PLANNING AND ZONING CASE CHECKLIST

P&Z CASE # SP2022-018 P&Z DATE 05/10/22 CC DATE _____ APPROVED/DENIED

PLANNING & ZONING CASE NO. SP2022-017

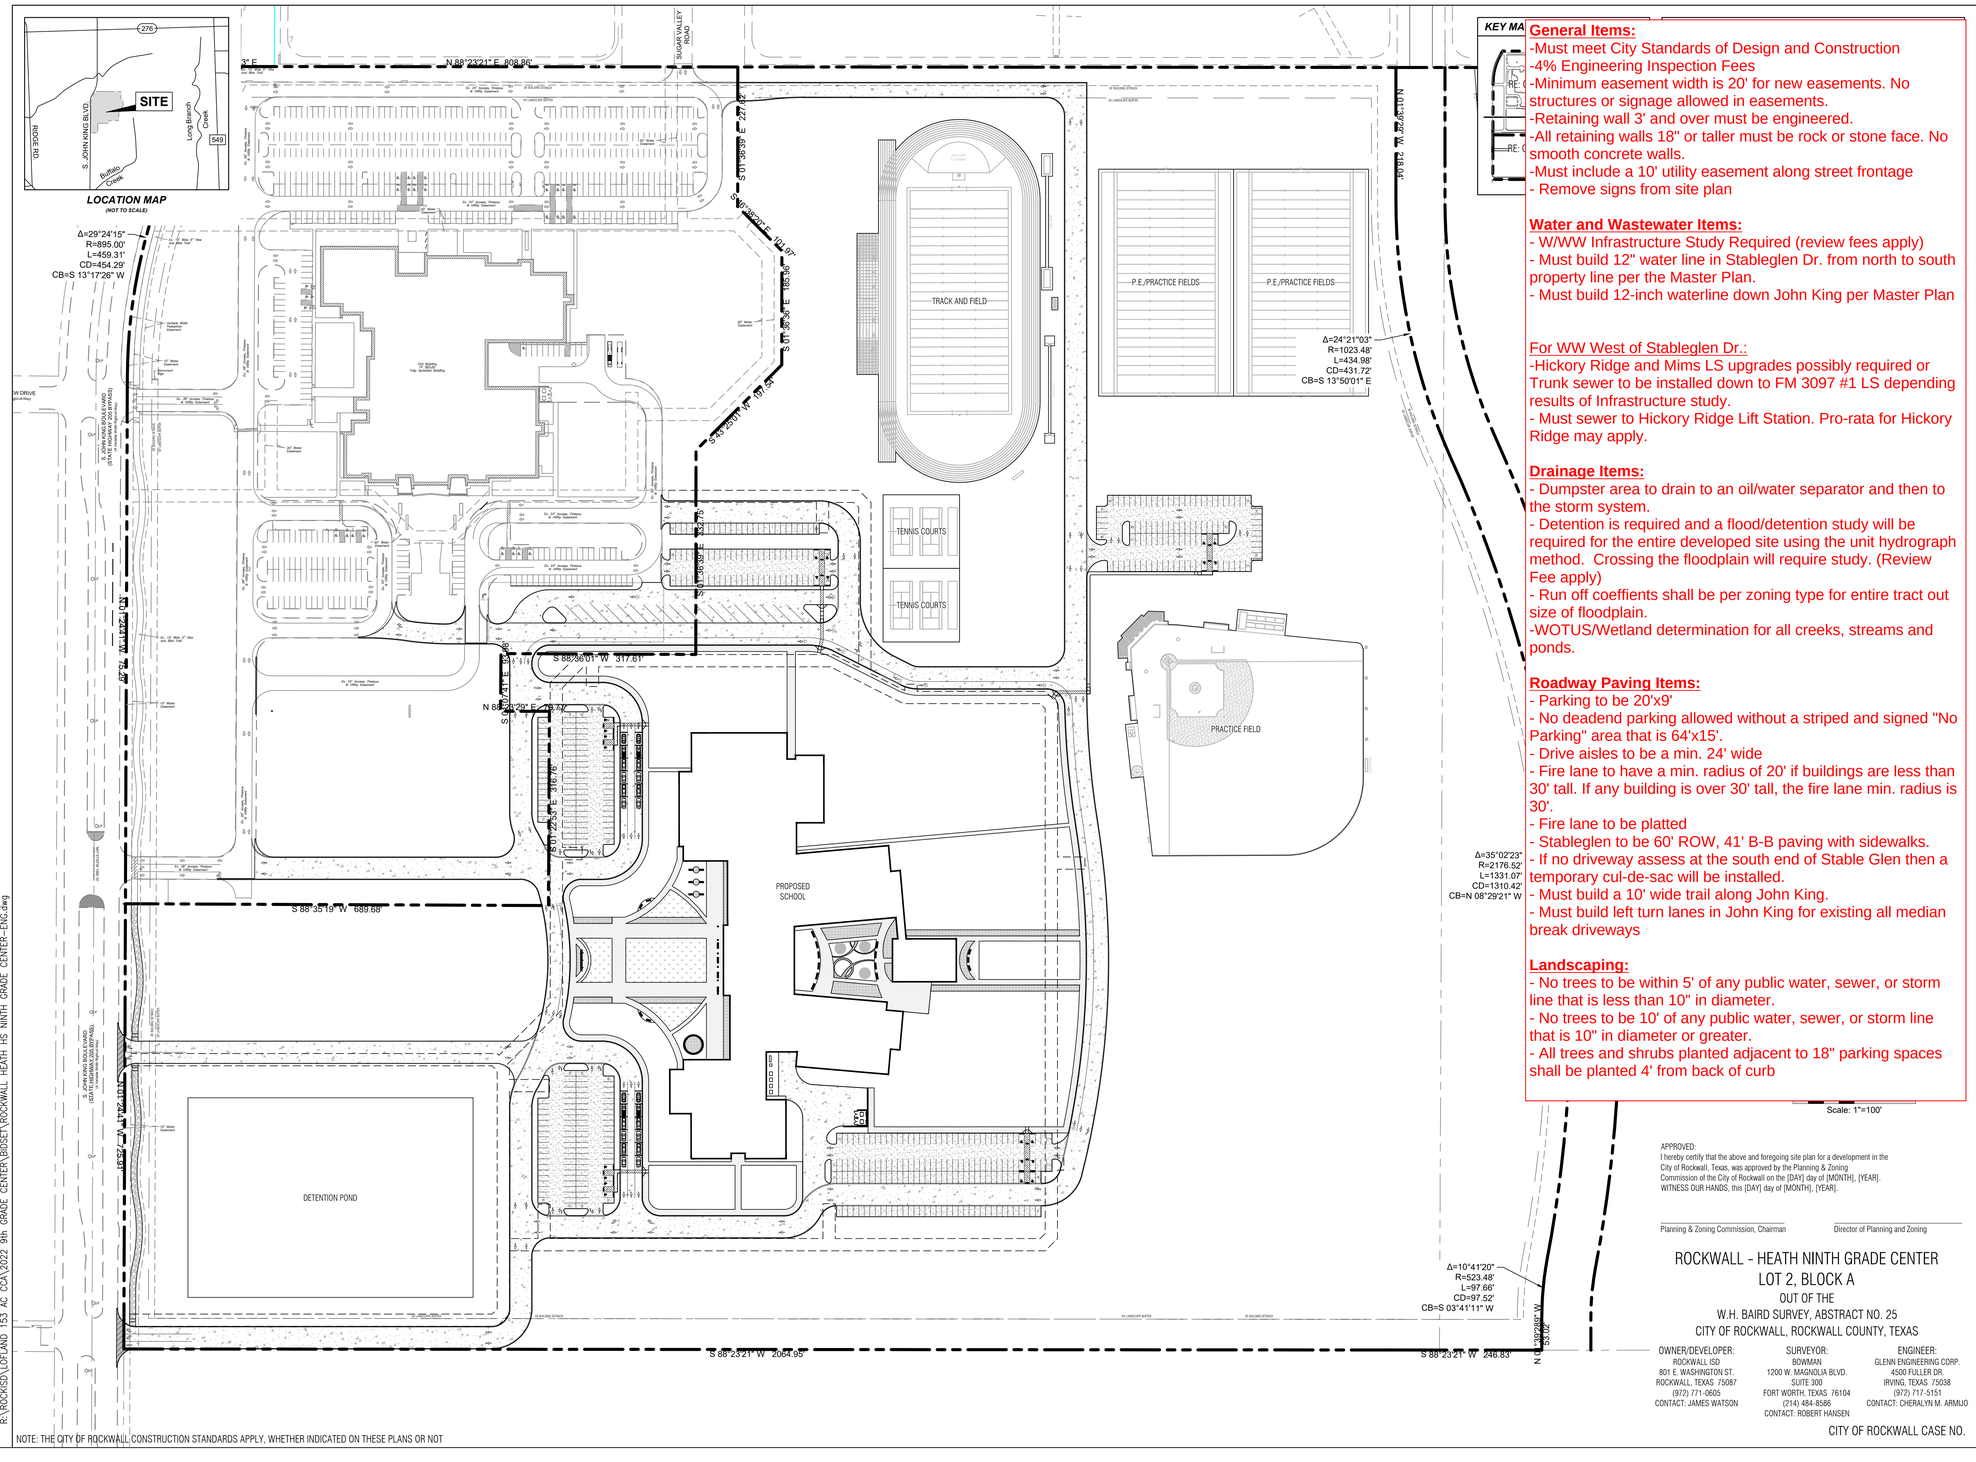
General Items:
-Must meet City Standards of Design and Construction
-4% Engineering Inspection Fees
-Minimum easement width is 20' for new easements. No structures or signage allowed in easements.
-Retaining wall 3' and over must be engineered.
-All retaining walls 18" or taller must be rock or stone face. No smooth concrete walls.
-Must include a 10' utility easement along street frontage
- Remove signs from site plan

Water and Wastewater Items:
- W/WW Infrastructure Study Required (review fees apply)
- Must build 12" water line in Stableglen Dr. from north to south property line per the Master Plan.
- Must build 12-inch waterline down John King per Master Plan
